CITY OF NEWTON
Department of Public Works
ENGINEERING DIVISION

MEMORANDUM

Re: Special Permit – 157 Herrick Road

*Benchmark at Andover Newton Theological School
Newton, MA
Prepared by: STANTEC
Dated: 5-12-'15*

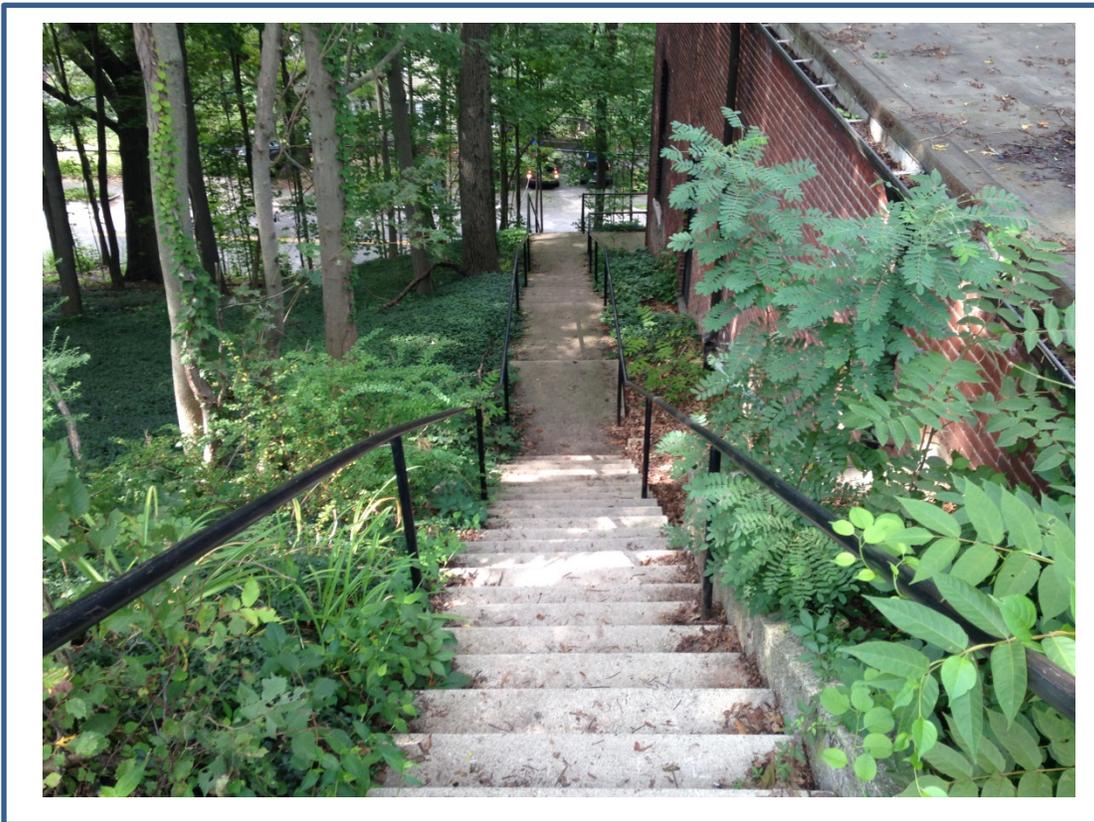
The plans also show a generic water service (the size needs to be indicated); furthermore, the building will require a dedicated fire suppression service connection separate from the domestic service. Siamese fire connection is also missing from the plan that the Fire Department will require. Furthermore, there is a concern for fire truck access and turning restriction from Herrick Circle onto the access driveway at the front of the building (see Sheet L-2.0) the curb line seems tight for fire apparatus maneuvering.
